Access Compliance Report

Public Rights-of-Way

(Curb Ramps)

Intersection ID: 6141	Main Street: CATHEY_RD	Cross Street: ENWOOD_DR	Location: S
ADA ID: DBDA3A84CF80	Ramp Type: Perp	Initial Pass/Fail: Fail	Overall Compliance: No
Severity Score: 22.5			
Codes/Mitigation Info/Possible Solution		Field Measurements/Component Compliance

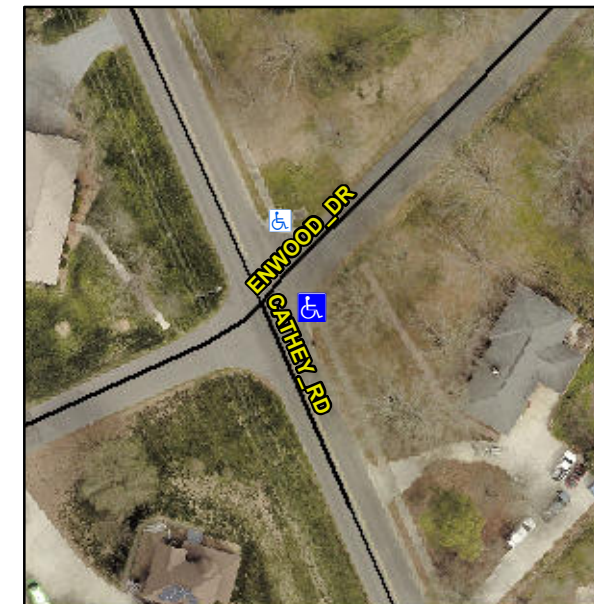
Not Found, R304.5.1, R304.2.2, R304.5.3

Compliance	Description	Data	Compliance	Description	Data
N/A	Ramp Length (in)	49.0	No	Ramp Slope (%)	8.4
No	Ramp Width (in)	47.0	No	Ramp XSlope (%)	2.7
N/A	Flare Type LT	N/A	N/A	Flare Type RT	N/A
N/A	Flare Slope LT (%)	N/A	N/A	Flare Slope RT (%)	N/A
N/A	Flare Traversable LT?	N/A	N/A	Flare Traversable RT?	N/A
N/A	Landing Length (in)	N/A	N/A	DWS Provided?	N/A
N/A	Landing Width (in)	N/A	N/A	DWS Contrast?	N/A
N/A	Landing Slope (%)	N/A	N/A	DWS Length (in)	N/A
N/A	Landing X Slope (%)	N/A	N/A	DWS Full Width?	N/A
N/A	Landing Curb? (Y/N)	N/A	N/A	DWS Offset (in)	N/A
N/A	Shared Landing?	N/A			
N/A	Gutter Ponding?	N/A	N/A	Gutter Slope (%)	N/A
N/A	Gutter Lip Ht (in)	N/A	N/A	Gutter X Slope (%)	N/A
N/A	Painted X Walk1?	No	N/A	Painted X Walk2?	N/A
	X Walk 1 Direction	To N		X Walk 2 Direction	N/A
N/A	X Walk 1 Width (in)	N/A	N/A	X Walk 2 Width (in)	N/A
	X Walk 1 Slope (%)	2.0		X Walk 2 Slope (%)	N/A
	X Walk 1 X Slope (%)	0.9		X Walk 2 X Slope (%)	N/A

Remove & Replace Entire Ramp.
